**Independent Assessment  
of  
Basement Impact Assessment for  
planning application 2014/1016/P  
at**

**38 Heath Drive  
London  
NW3 7SD**

**for  
London Borough of Camden**

Report Ref: **LBH 4239 Ver 1.0**

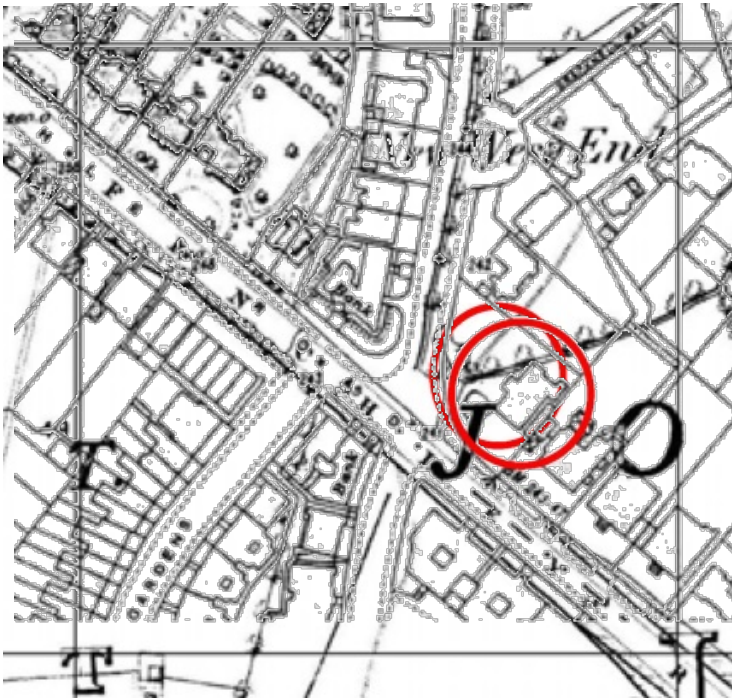
Document 1 indicates that a contiguous piled wall will be installed around the perimeter of the proposed basement to act as a retaining structure both in the temporary and permanent conditions. Document 7 envisages that this wall will not be propped other than possibly in the vicinity of the deep excavation for the pool.
